Value Engineering Study Report – Final

I-69 Ohio River Crossing Project Evansville, IN and Henderson, KY

August 2, 2019

Idea Title	Modify Veterans Memorial Parkway interchange
Function	Support Redundancy

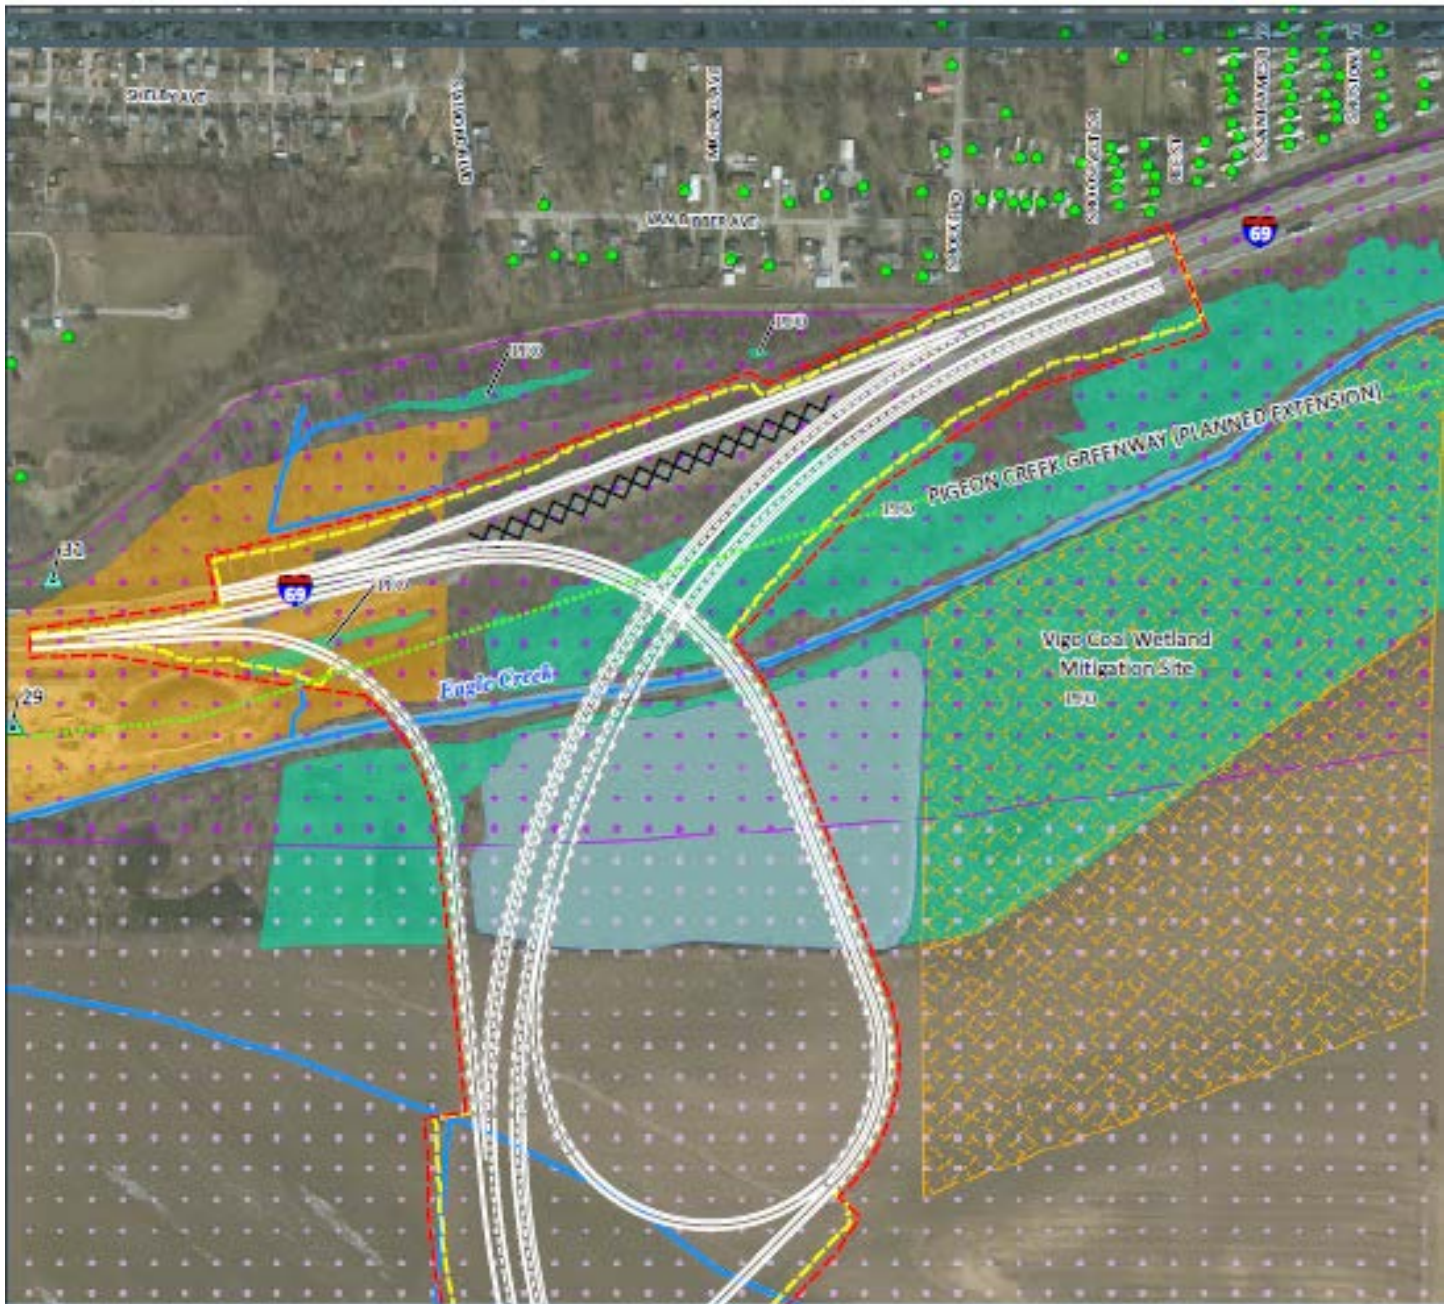
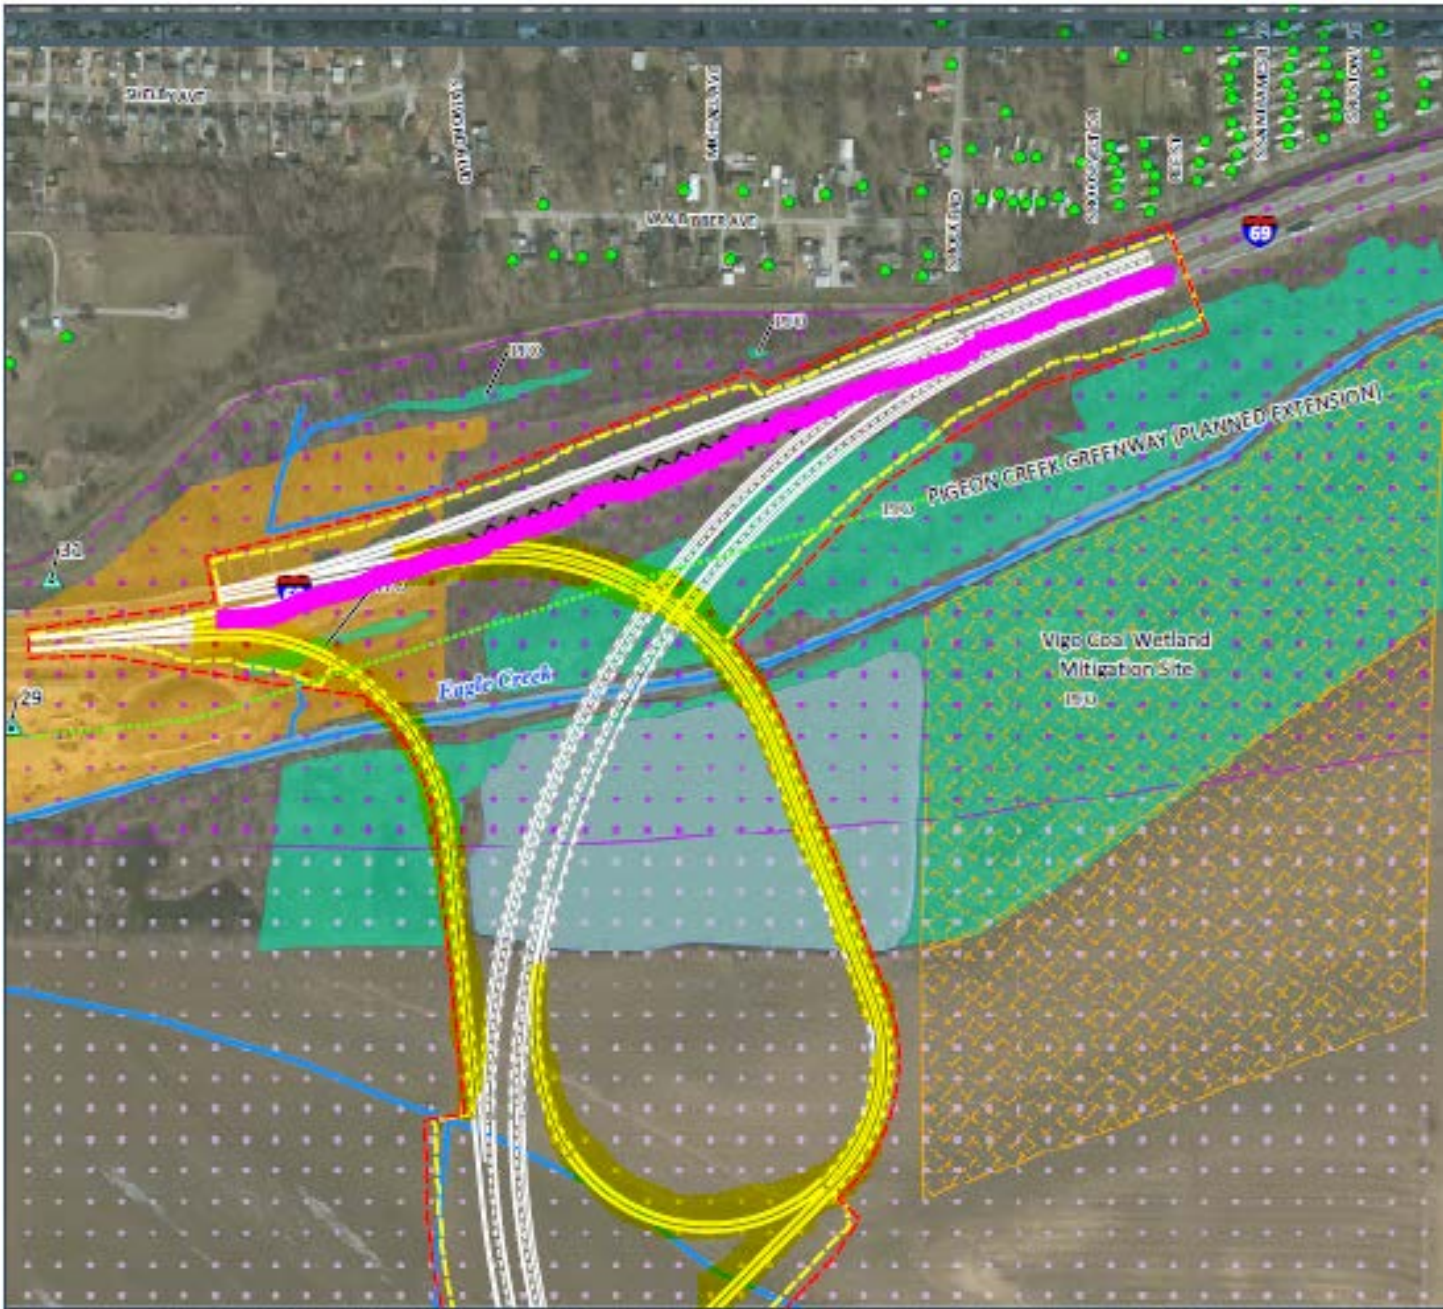
Delete access from east bound Veterans Memorial Parkway to southbound I-69 and northbound I-69 to westbound Veterans Memorial Parkway. Maintains east-west connectivity along Veterans Memorial Parkway.

FHWA approval of a new partial interchange on the interstate system may be difficult.

Eliminate

Idea Title	Remove KY2084 ramp southbound
Function	Support Redundancy

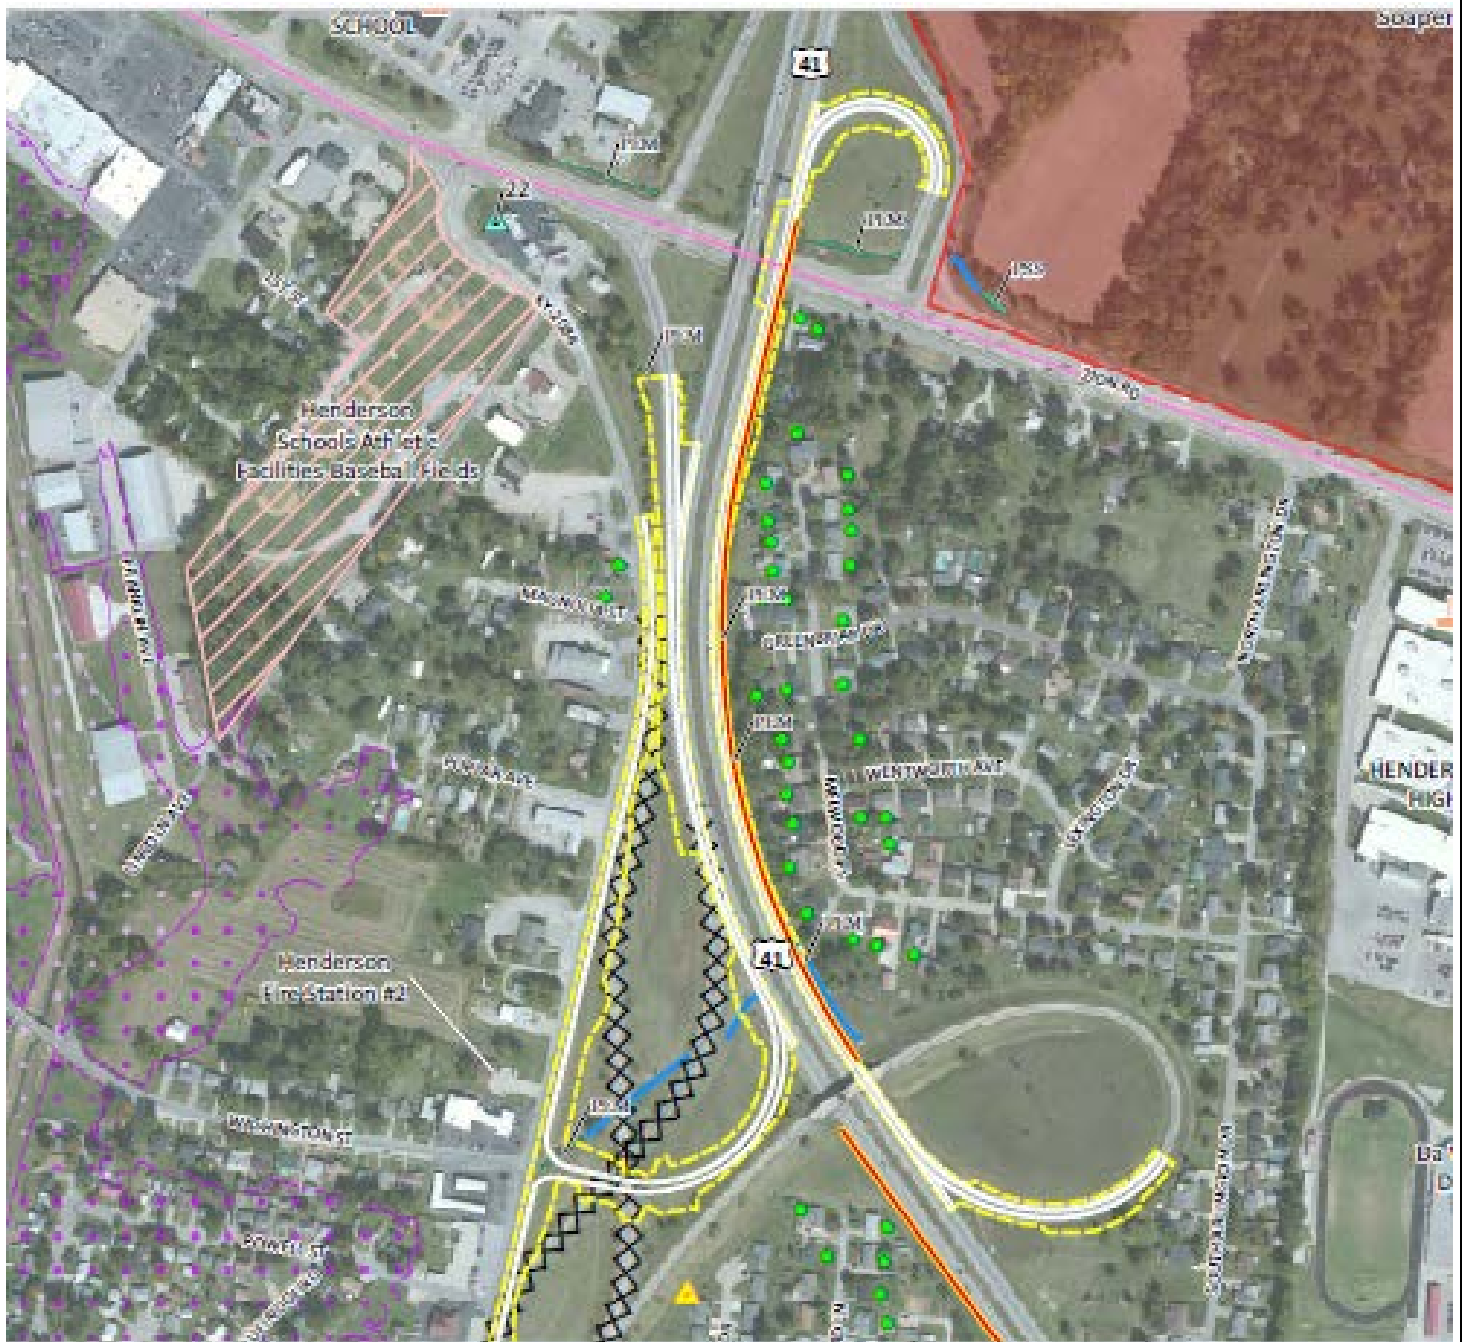
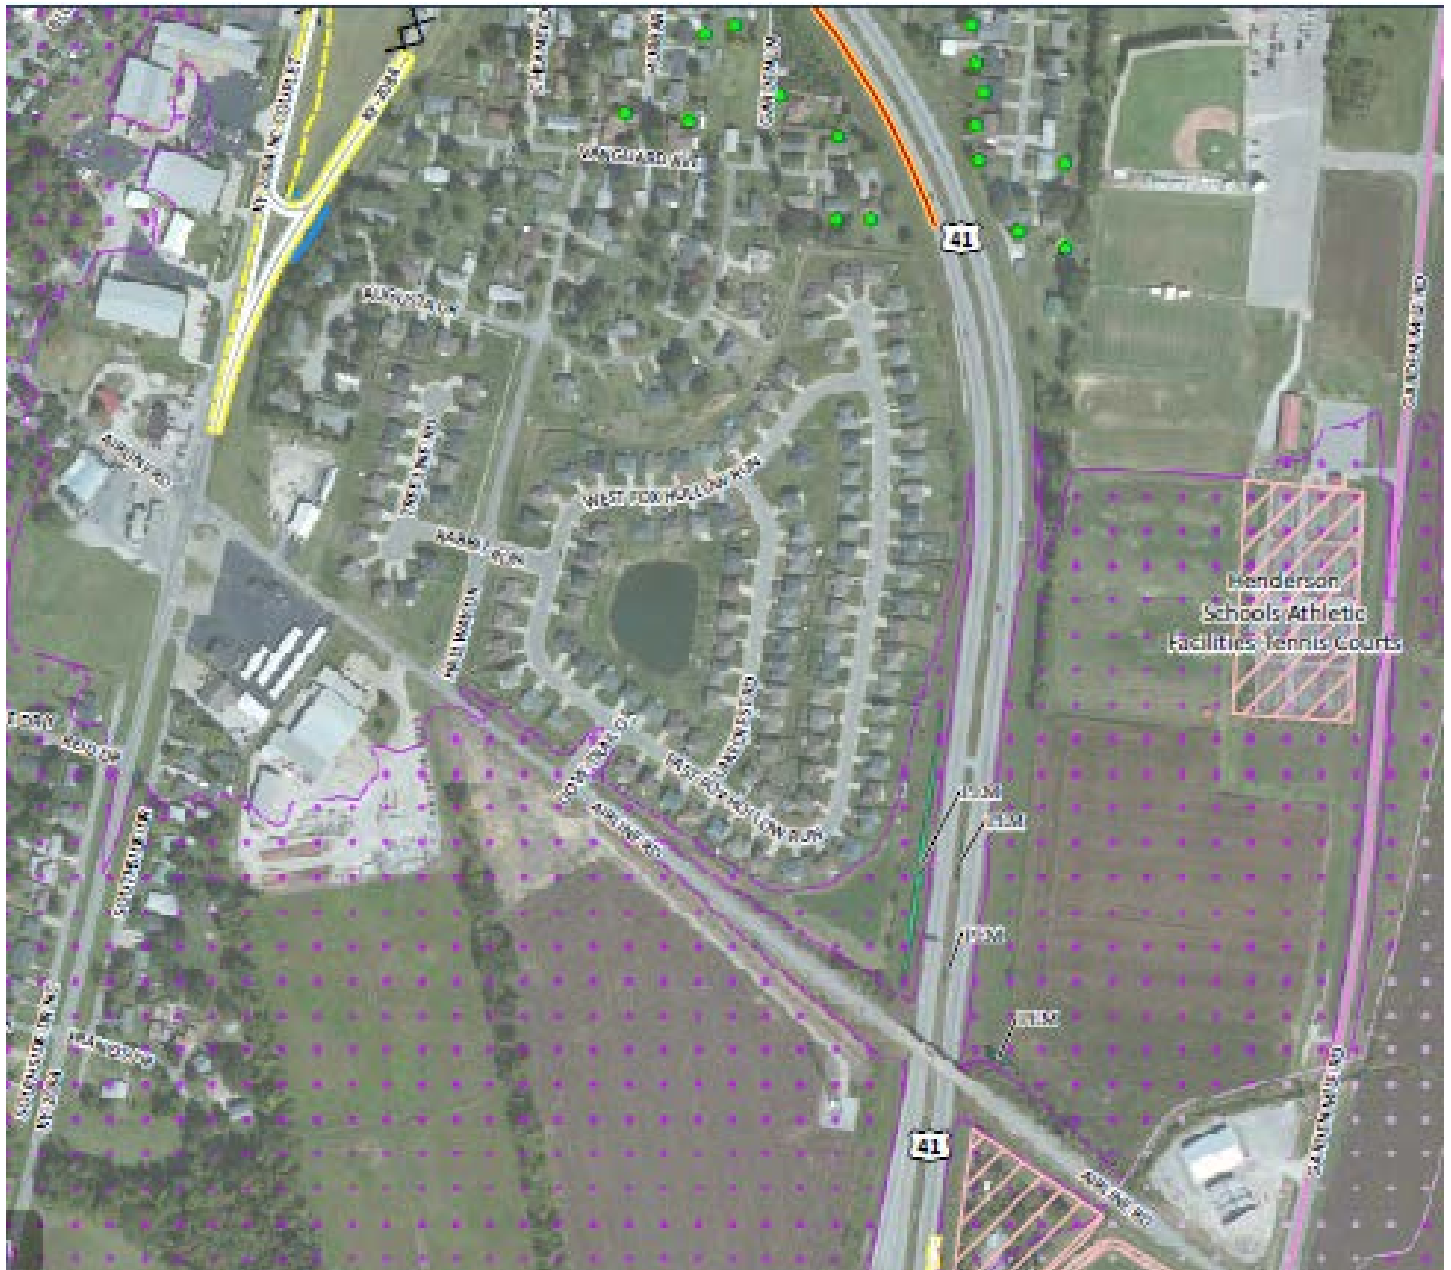
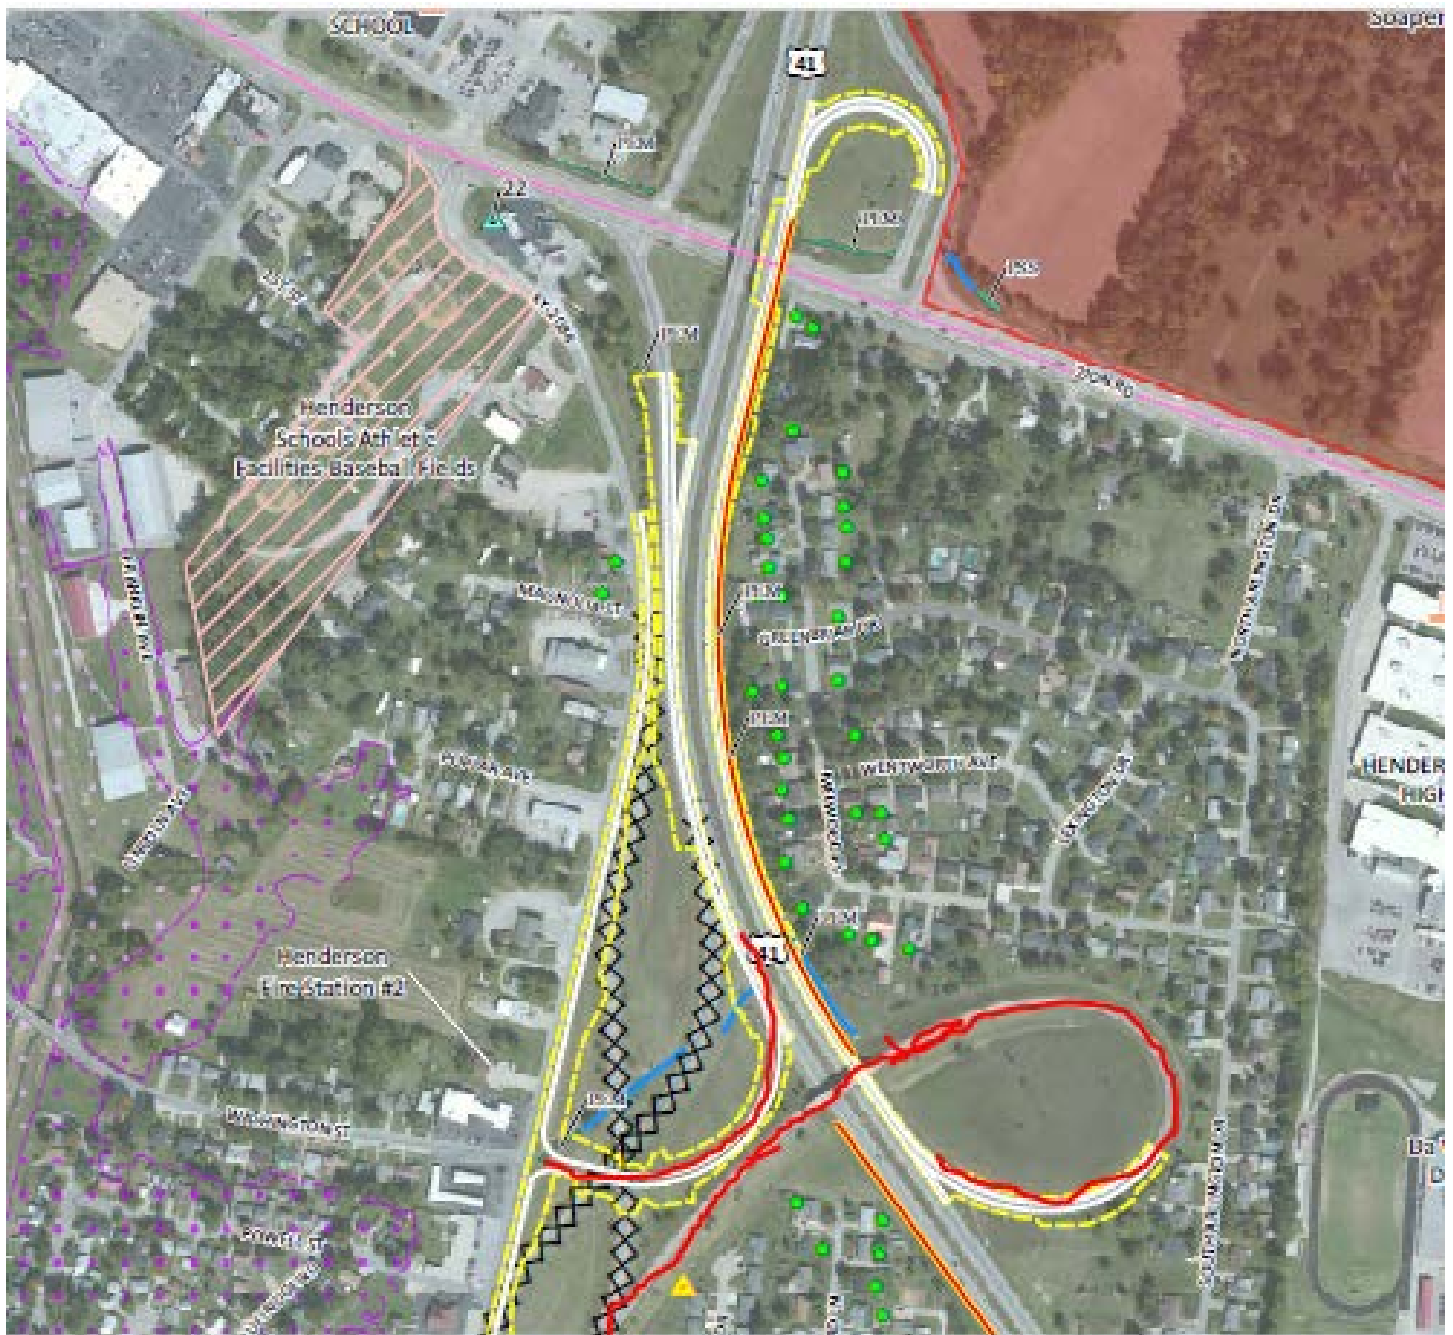
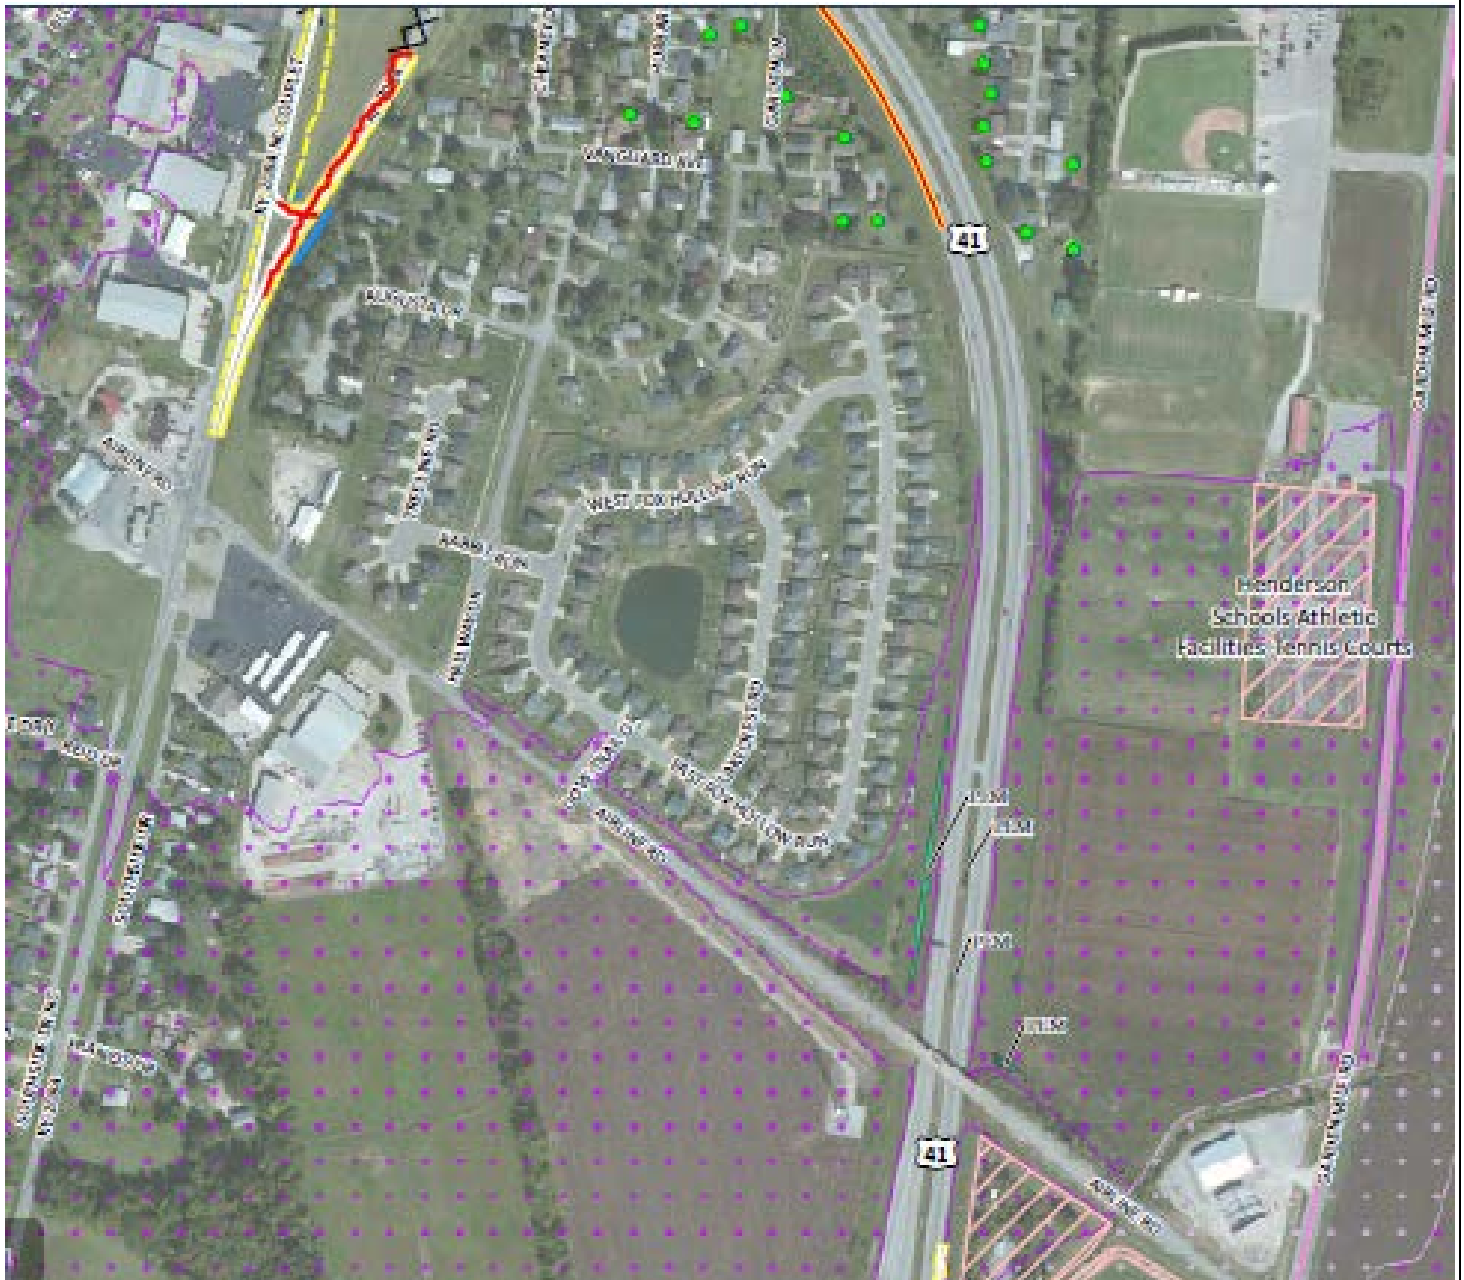
Remove KY 2084 interchange with US 41/I-69. This interchange is less than ½ mile from the KY 351/2nd Street interchange. Removal of KY 2084 interchange increases safety along the corridor due to the extreme close proximity of interchanges thereby reducing traffic movements/weaving within this short distance. Current interchange has minimum traffic volume compared to the immediate northern and southern interchanges. Impact to motorist is minimum, approximately one mile increase in distance to access US 41/I-69.

The removal of the KY 2084 interchange likely reduces the need for a design exception and reduces driver “decisions” in the area.

Proposed Removal
